Intel 430MX PCIsset 82437MX (MTSC)/82438MX (MTDP) and 82371MX (MPIIX) Specification Update

Release Date: December 1997

Order Number 297656-004

1. Power Plane Control

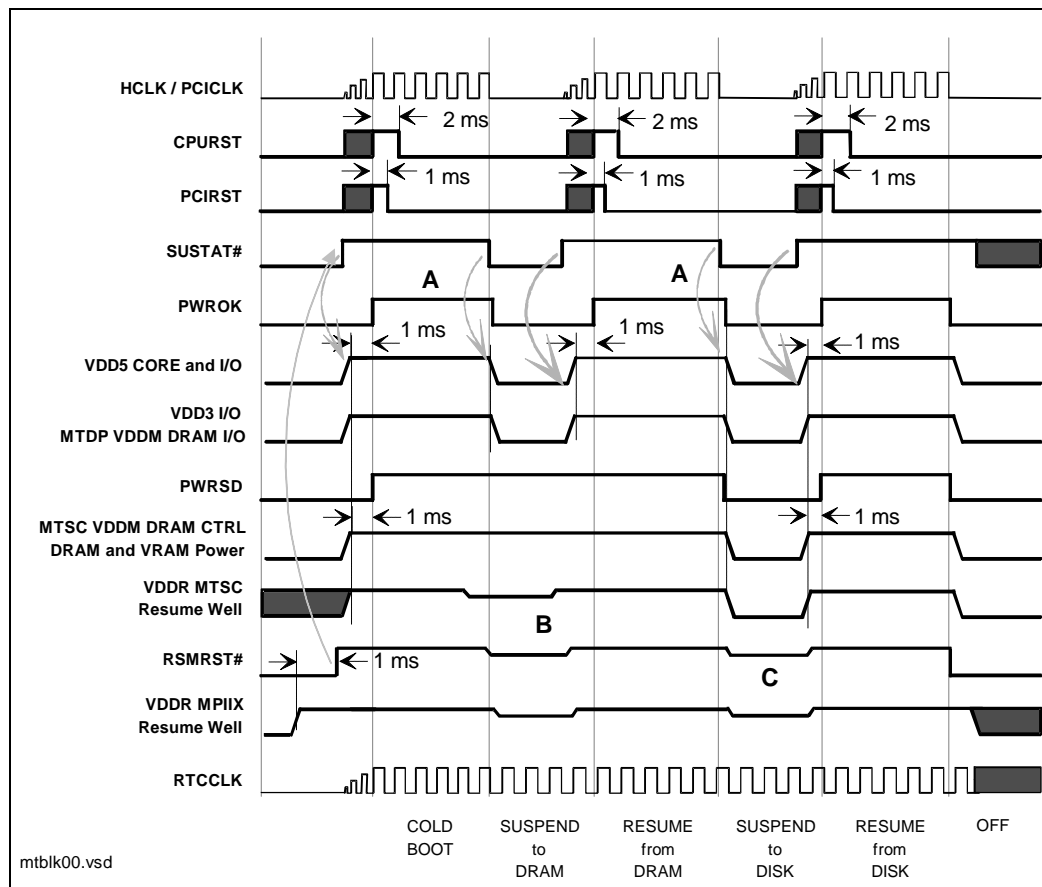
The following diagram provides a valid SUSTAT# signal at cold boot in order to turn on the power plane:
